UNITED STATES PATENT AND TRADEMARK OFFICE

APPLICATION NO.	FILING DATE	FIRST NAMED INVENTOR	ATTORNEY DOCKET NO.	CONFIRMATION NO.
09/660,439	09/12/2000	Toshiyuki Takemori	001155	6603

Office Action Summary

TAKEMORI ET AL.

FIG. 4H.

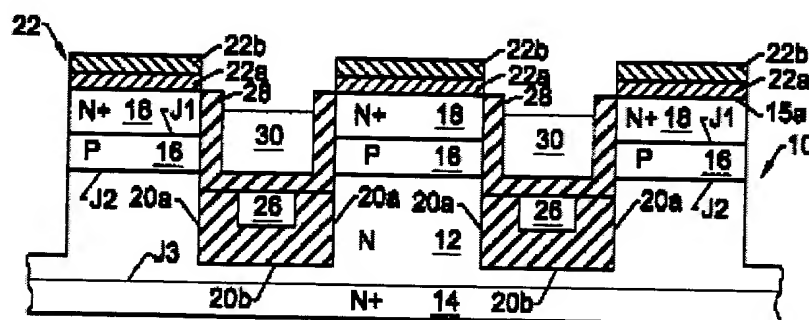
a source region formed of the first conductivity type provided inner surface of said conductive region and exposed on side surface of said trench. (Baliga fig. 4 H- see below).

and a gate insulating film provided on the side surface of said trench, “ an upper part of the gate insulating film being in contact with a lower part of said source region , a bottom part being in contact with an upper part of said drain layer, and a middle part being in contact with conductive region”.

Baliga does not specifically state or describe a bottom part being in contact with
 an upper part of said drain layer.

Therefore it would have been obvious to one of ordinary skill in the art at the time of the invention to include Sapp's gate insulating film having its bottom part being in contact with upper part of drain region in Baliga's device to provide isolation trenches that allow large anode contact area that connects to the trench MOSFET source terminal thus resulting in better devices. (Sapp col. 4 lines 60-65).
